MOUNTING OF IR-DRDO  
BIO-DIGESTER SYSTEM ON LHB  
COACHES (LH)INDIAN RAILWAY STANDARDS  
INTEGRAL COACH FACTORY, CHENNAI - 600038

सं/No. MD/FUR/LAV. FIT/101

Corrosion of J-brackets on under frame for mounting of Bio retention tank in LHB coaches.

With respect to above subject, a retro fitment Bolted design J-Bracket in SS-316L material is developed and issued the drawings for retro fitment & reuse of existing dismounted Bio retention tanks to drg. Nos. 32963203 & 32963204 from the corroded brackets.

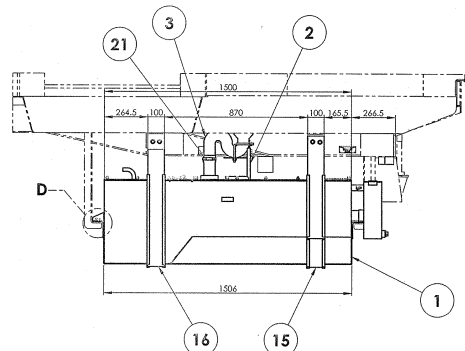
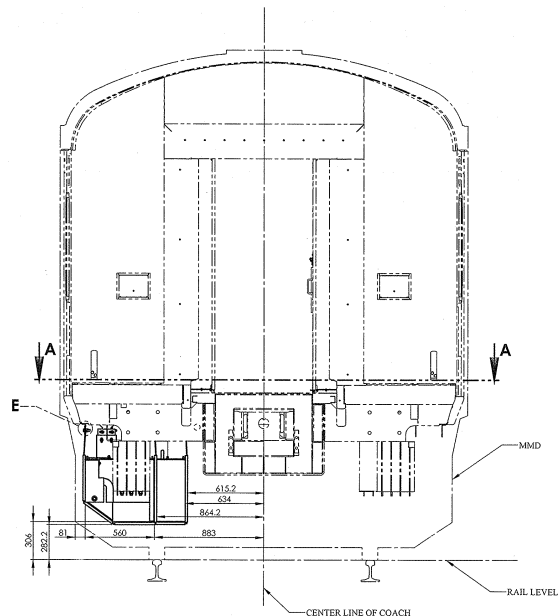
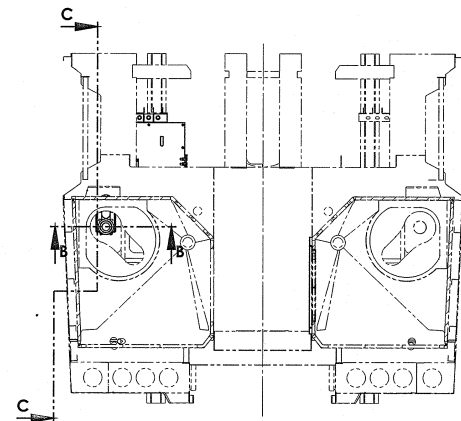
REVISIONS				APPROVED & DATE
ALT.	ZONE	DESCRIPTION		
a		1) DISC. & MATERIAL SPEC. OF ITEM-4 ALTD. FROM PVC SUCTON 10% ROLL GRAM. IS 1325-2002 TO RUBBER 2) ROLL GRAM. DIA 63MM. IS 1402-2001, TYPE-B. 3) NOTE-1 ADDED. 4) REF. SPEC. OF ITEM-22 UPDATED AS PER RDSC/CC-16094, ALT-2. VIEWS UPDATED ACCORDINGLY.		-SD-
b		DIMENSION OF ITEM-4 ALTD. FROM NOMINAL DIA 63MM TO NOMINAL DIA 70MM

32963250

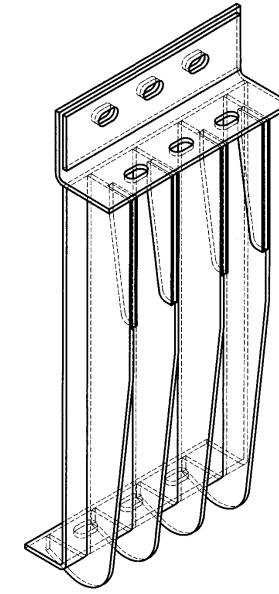
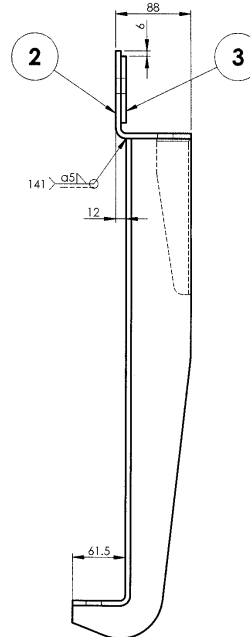
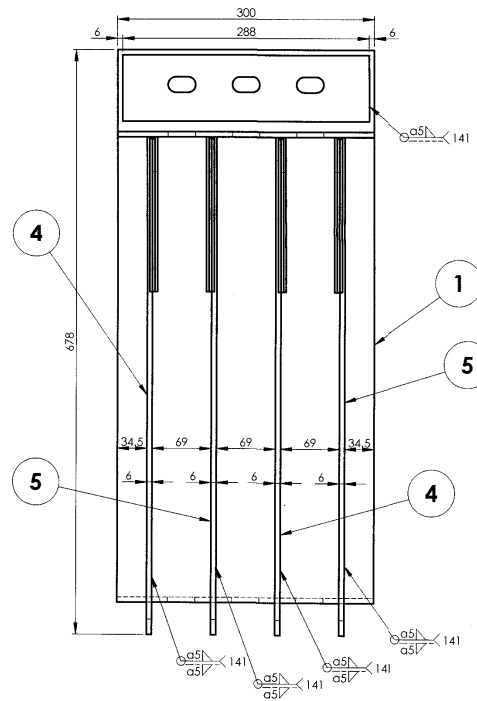
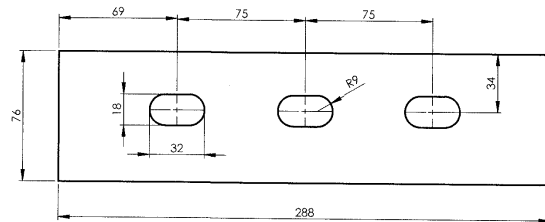
5. If found necessary, then inner J-bracket shall be cut and removed from the end part member up to the bottom of member. Ground the removed bracket area at the bottom of the end part member to ensure full surface contact area for the butting of J-bracket to drg. No. 32963250. Special care shall be taken to avoid damage of end part member while cutting of corroded J-brackets.

32963251

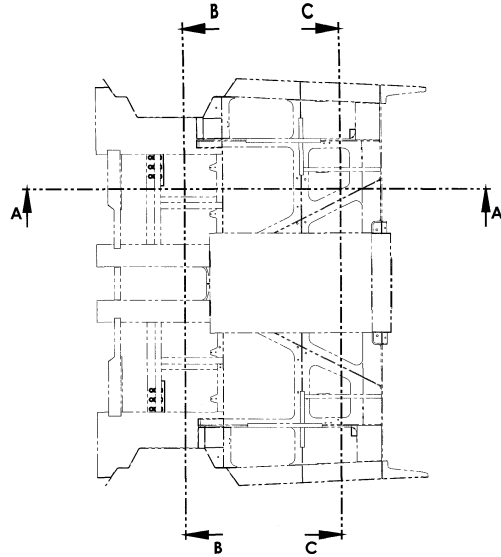
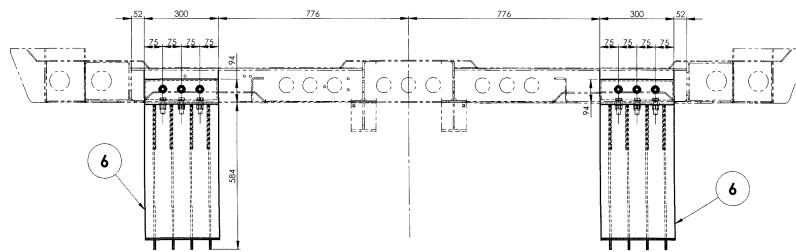
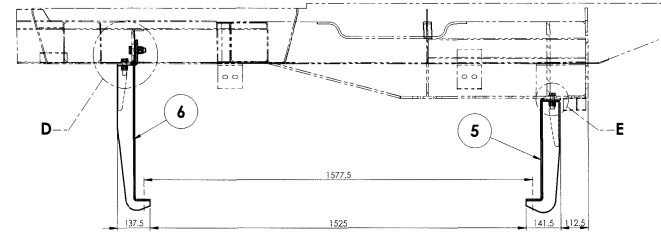
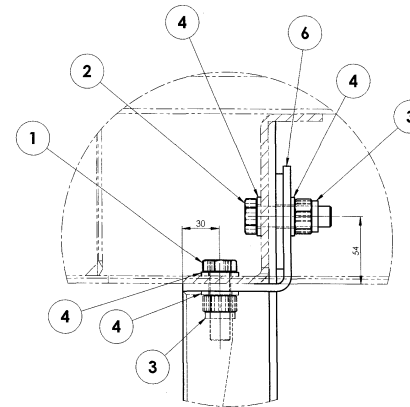
1. MANUFACTURER OF ITEMS 1, 2 & 3 SHALL BE UNBRAKO OR TVS OR LPS ONLY.
2. THIS DESIGN APPLICABLE FOR RETROFITMENT OF SAME BIO RETENTION TANK IN COACHES WITH CORRODED J-BRACKETS.

8. Assemble the outer J-bracket with outer head stock by using fasteners as shown in the drg. No. 32963251.
9. Assemble the inner J-bracket with end part member by using fasteners as shown in the drg. No. 32963251.
